NOTICE OF PLANNING & ZONING COMMISSION MEETING

City of Cumming

GREAT WESTERN COTTAGES
GENERAL NOTES AND DETAILS

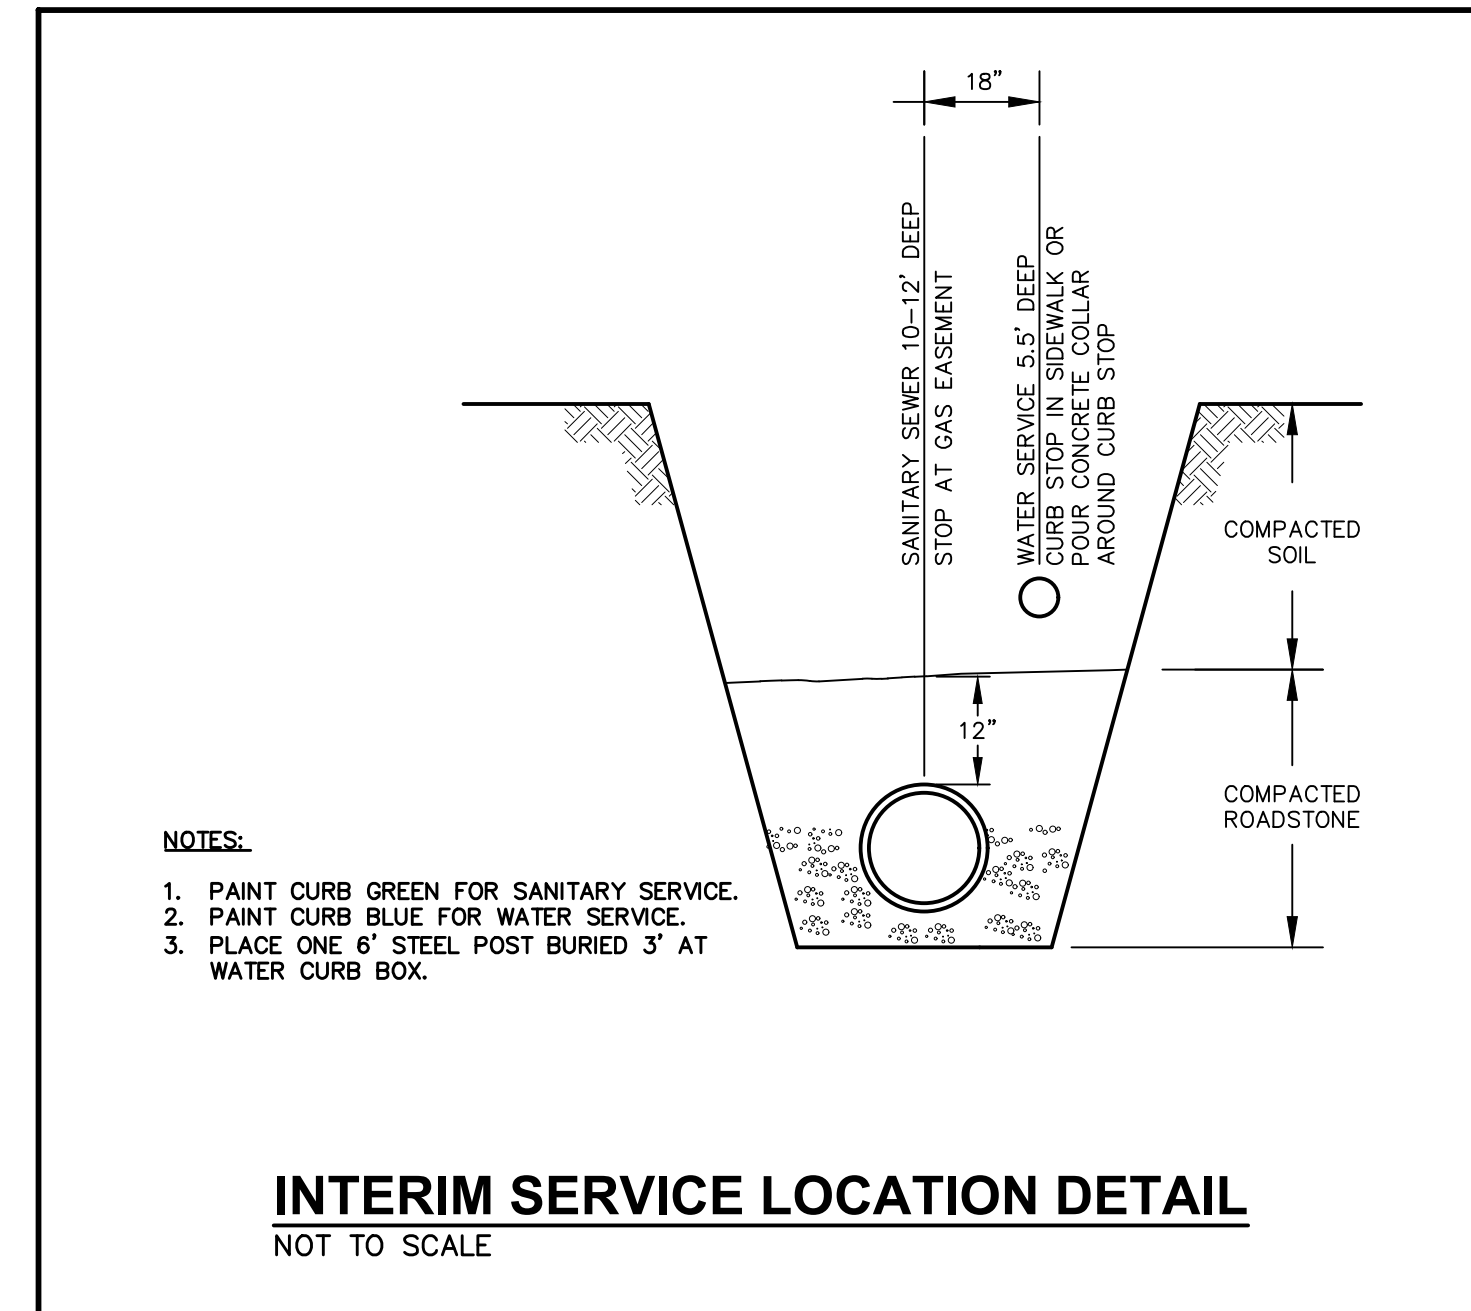
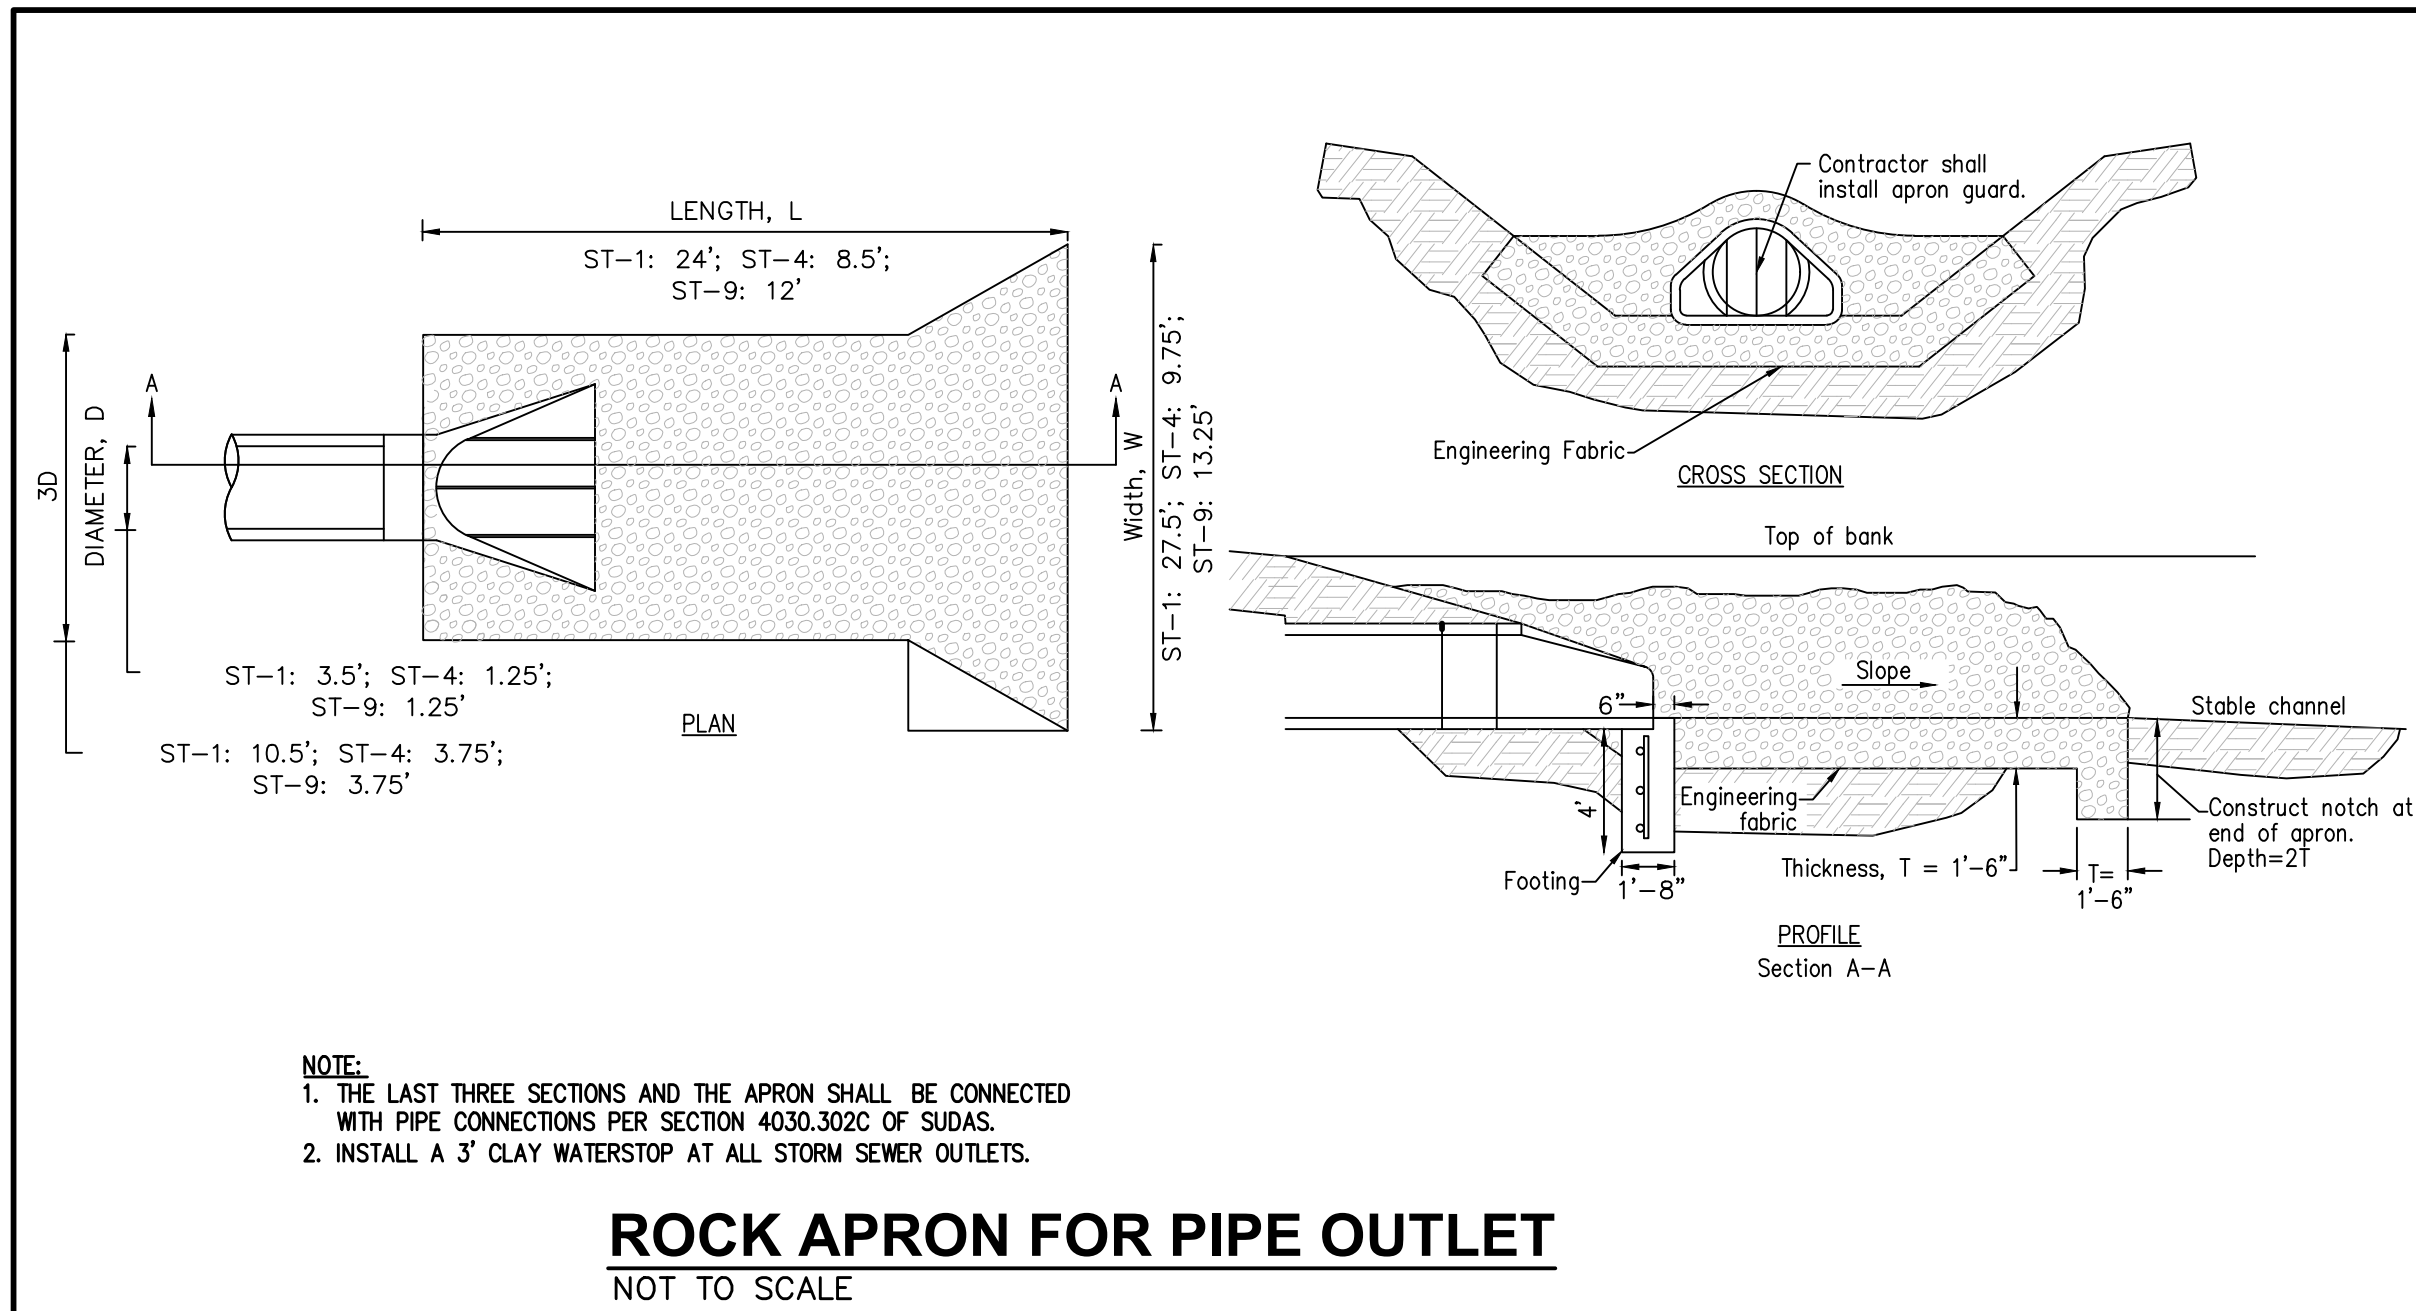
FILE: H:\2024\2405385\DWG\2405385-SITE PLAN.DWG COMMENT: DATE PLOTTED: 1/29/2025 6:00 PM PLOTTED BY: ROSALIA STONEBERG DESIGNED BY: ENR

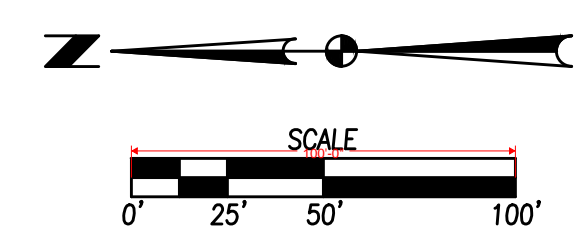
FILE: H:\2024\2405385\2405385-SITE PLAN.DWG
 COMMENT: ENH
 PLOTTED BY: ROSA STONEBERG
 DATE: 1/30/2025 6:00 PM

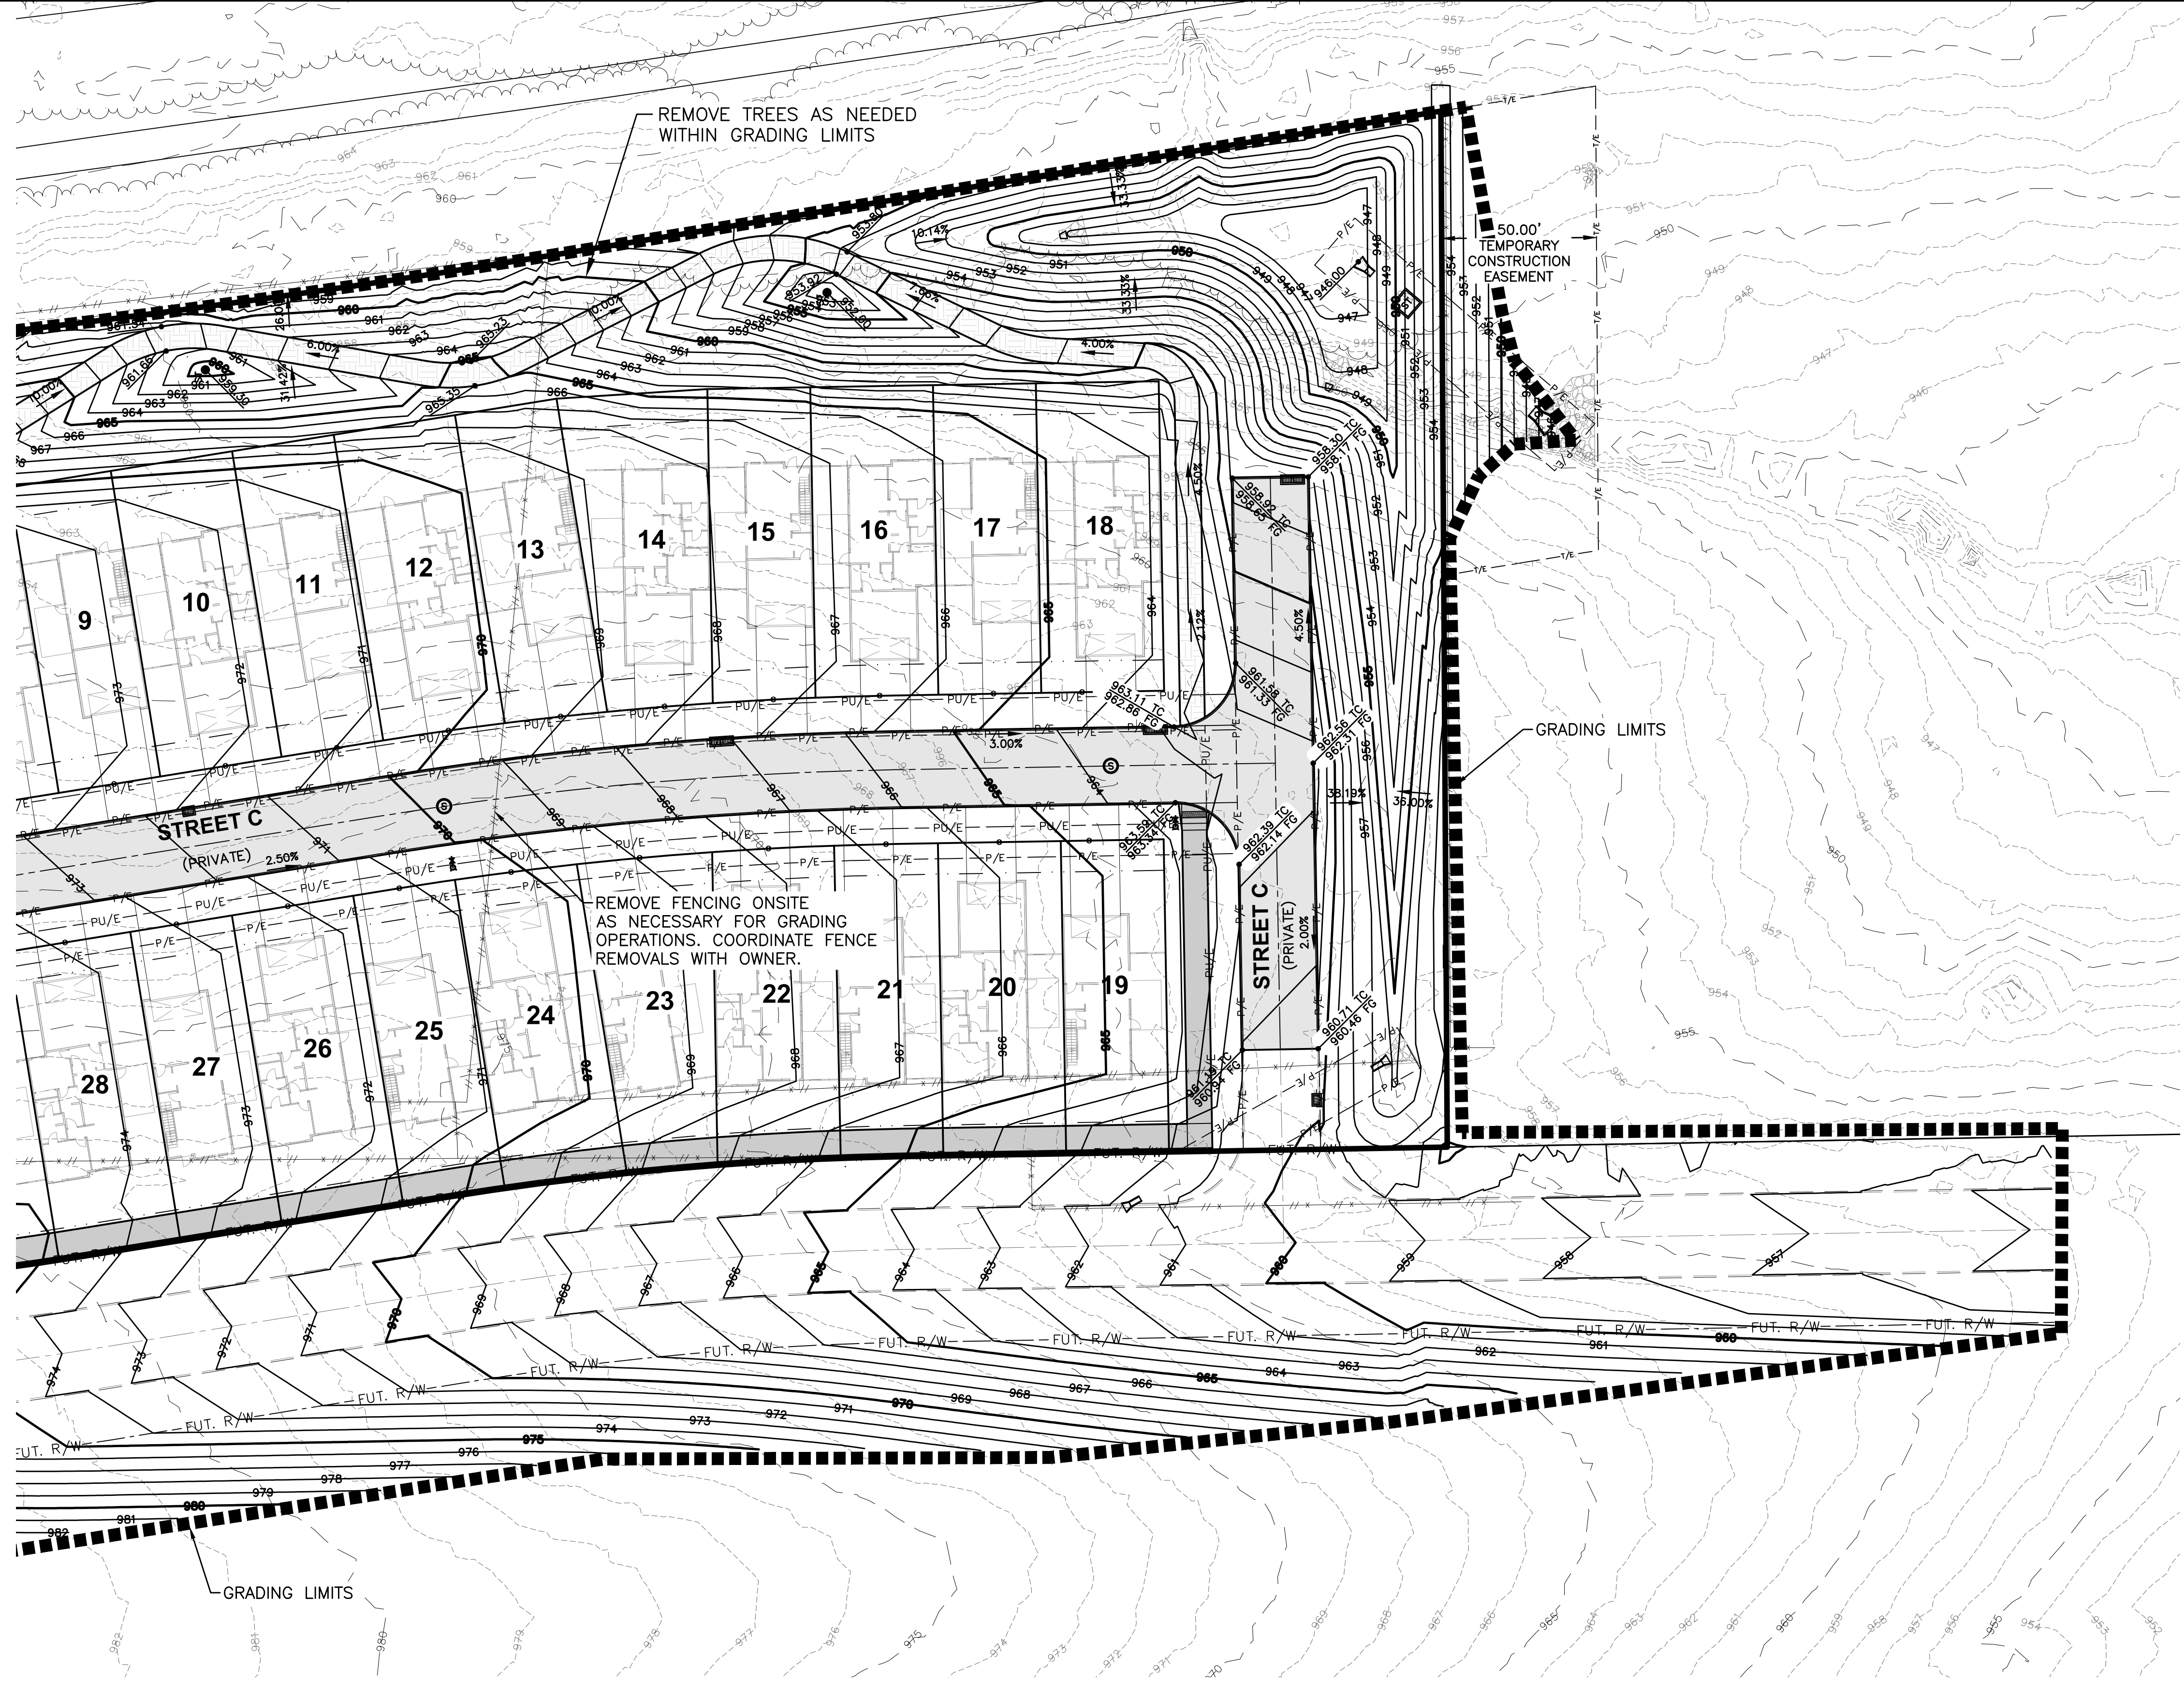
FILE: H:\2024\2405385\WORK\2405385-SITE PLAN.DWG. COMMENT: 1/29/2025 6:00 PM
PLOT: 1/29/2025 6:00 PM. PLOTTED BY: ROSALIA STONBERG. DESIGNED BY: ENH
